Monitor Cradle (12)

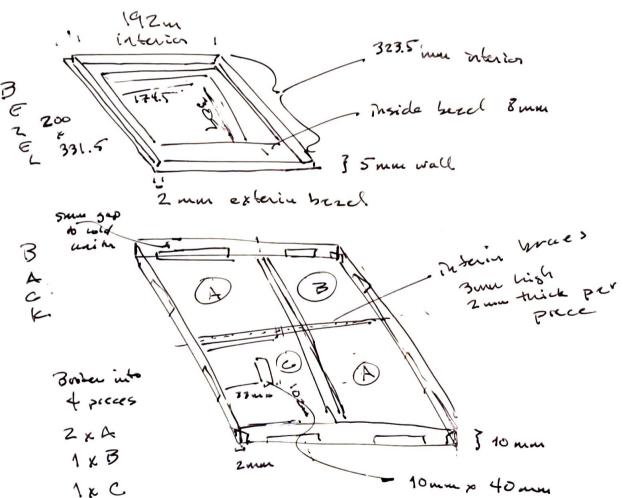
1 mm is too thin. separates too easily.

-increase longe flat awas to 2 mm.

sides appear to be fine

Add supports to back. 3 mon high 10 327.5mm hen goht piece in the middle of those support the back to gether. Uning need 2 types - with cubic hale ritual cubic hale. 1 mm is too thin. separates too easily.

- keep bezel. Maybe increuse size of screw Wes

- make new back, breaking in to 4 quadrants to be glued together. V1 didn't print well b/c plate was too big.

- increase walls to zmy or more.

- increase depth of back to 10 min , possibly hezel
